UNITED STATES PATENT AND TRADEMARK OFFICE

APPLICATION NO.	FILING DATE	FIRST NAMED INVENTOR	ATTORNEY DOCKET NO.	CONFIRMATION NO.
09/532,786	03/22/2000	Nobuhiko Hayashi	000351	8588

Office Action Summary

DETAILED ACTION

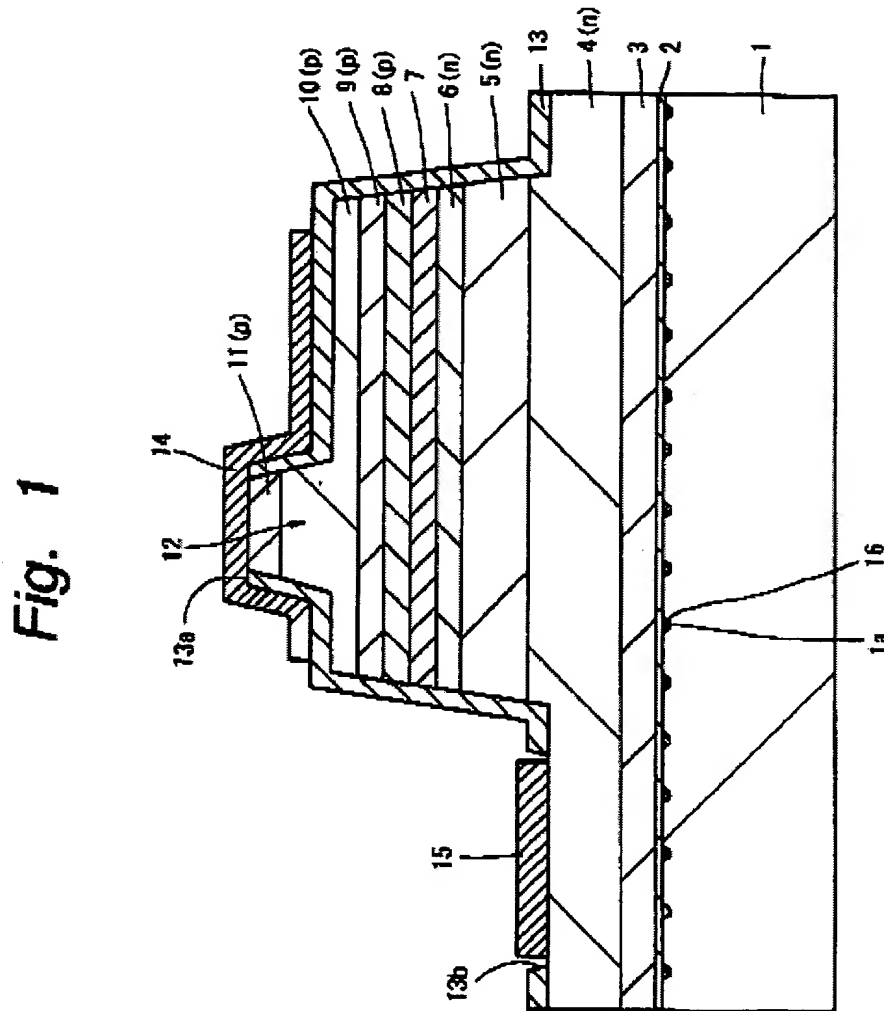
With respect to claims 1, 11 and 12, Morita discloses a semiconductor device on a sapphire substrate comprises a GaN semiconductor laser includes a sapphire substrate (1), recesses (1a), a GaN buffer layer (2), a ridge portion (12), insulating film (13) has formed an opening (13a, 13b), undoped GaN layer (3), the n-type GaN contact layer (4n), AlGaIn cladding (5n), the n-type optical guide (6n), the active layer (7), p-type AlGaIn cap layer (8p), p-type optical guide (9p), AlGaIn cladding (10p), the p-type GaN contact layer (11), electrode (14, 15) AlGaIn crystal (16), note cols. 6-12, see fig 1.

With respect to claim 2, Morita discussed about the current blocking layer and the nitride based semiconductor containing at least one of indium, gallium, aluminum, boron and thallium, note cols. 8-12, see fig 1.

With respect to claim 3, Morita discloses the nitride based semiconductor laser (2), n-type cladding layer (5n), p-type cladding (10p) and ridge portion (12), note cols. 7-8, see fig 1.

With respect to claims 7 and 15, Morita discussed about the second nitride based semiconductor laser is formed so as to cover a region above opening and a region on current blocking layer, note cols. 7-8, see fig 1.

With respect to claims 8 and 16, Morita discussed about the type electrode formed on second nitride based semiconductor laser, note cols. 7-8, see fig 1.

With respect to claim 13, Morita discussed about the first nitride-based semiconductor (2), n-type cladding layer (5n), p-type cladding (10p), note col. 7, see fig 1.

With respect to claim 18, Morita discussed about the plurality of nitride based semiconductor layers containing at least one of the indium, gallium, aluminum, baron and thallium, note cols. 12-13, see fig 1.
